Technical Service Bulletin

Technical Service Bulletin: TSB190042	Released Date: 24-Jun-2019
New Vented Coolant Drain Line Kit to Reduce Variable Geometry Turbocharger Actuator Overheating: FC2636 and FC1894

Figure 1, Coolant Vent Line Routing. OEM Top Tank (1). VGT Actuator (2).

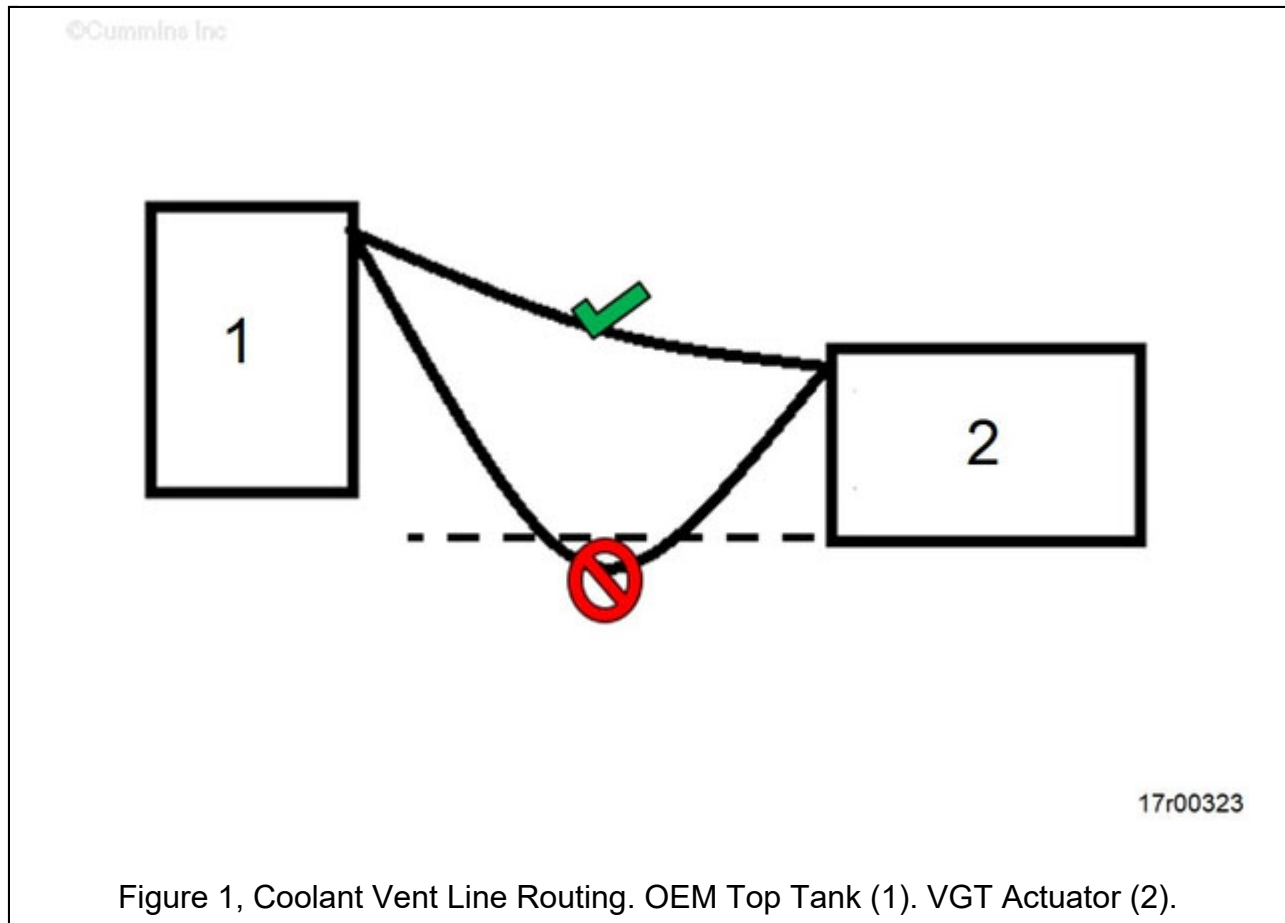
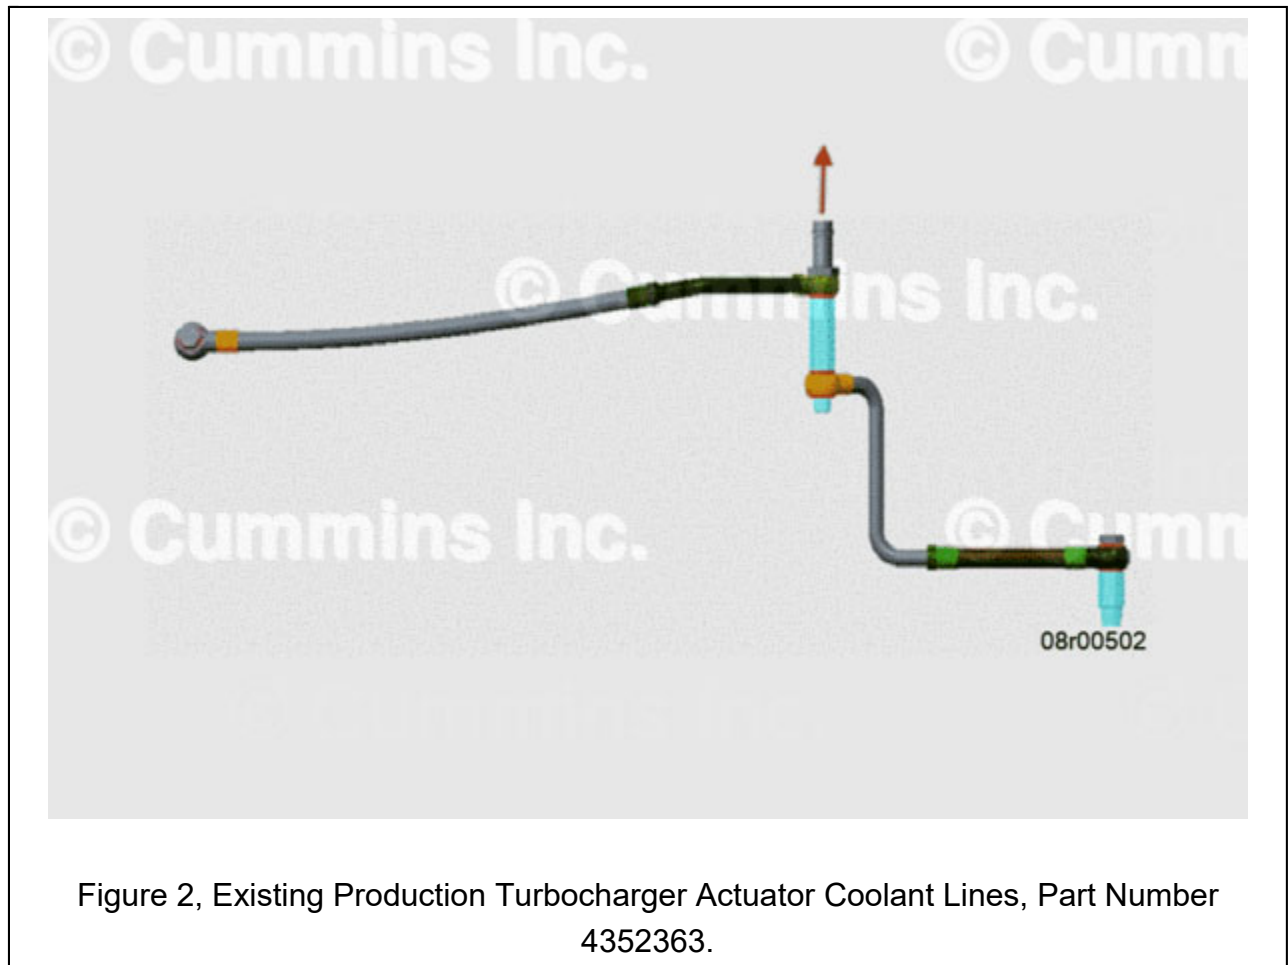
- New turbocharger actuator vented coolant drain line kits are available with a horizontal or vertical outlet.
- Turbocharger actuator vented coolant drain line orientation **must** be determined in order to determine correct service kit to be ordered. See Figures 1, 2, 3, and 4 for existing product and service kit layouts.
- See Figure 5 for new production routing.
- See Table 1 for kit part numbers.
- For new turbocharger actuator coolant drain line kit installation, see corresponding Service Manual. Reference Procedure 008-017 in Section 08.
- Dips or sags of the coolant vent line below the bottom surface of the actuator should be avoided. If the coolant vent line to the OEM top tank, dips or sags below the bottom surface of the turbocharger actuator, the coolant vent line **must** be shortened and raised to be above the top surface of the turbocharger actuator. See Figure 1 below.

Replace turbocharger actuator vented coolant drain line with corresponding kit.

Figure 4, New Self-Assembled Turbocharger Actuator Coolant Lines Kit, Part Number 5473159.

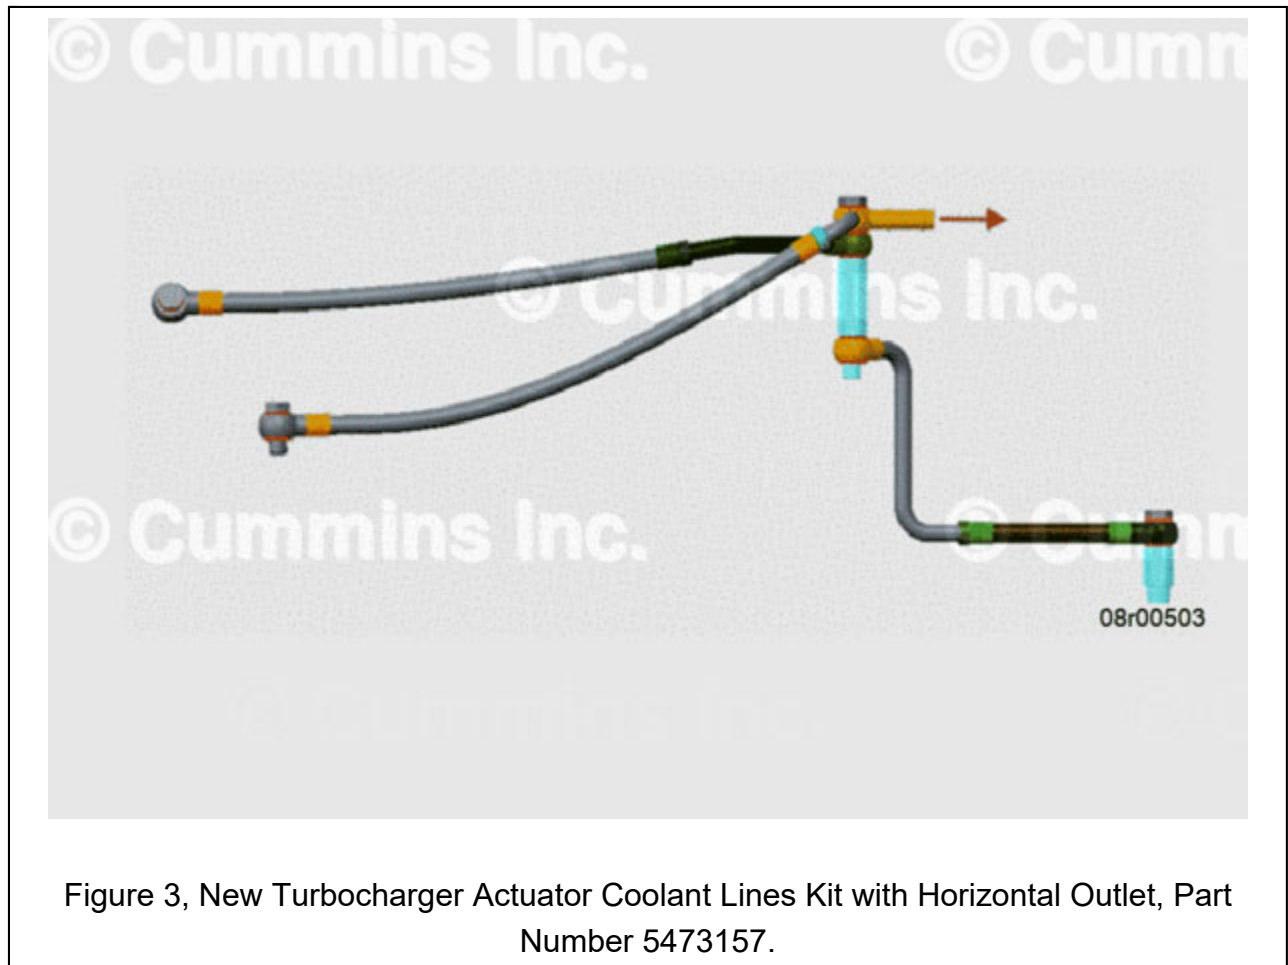
Service kits contain a new turbocharger actuator vented coolant drain tube with vent accommodation, turbocharger vent line and associated hardware.
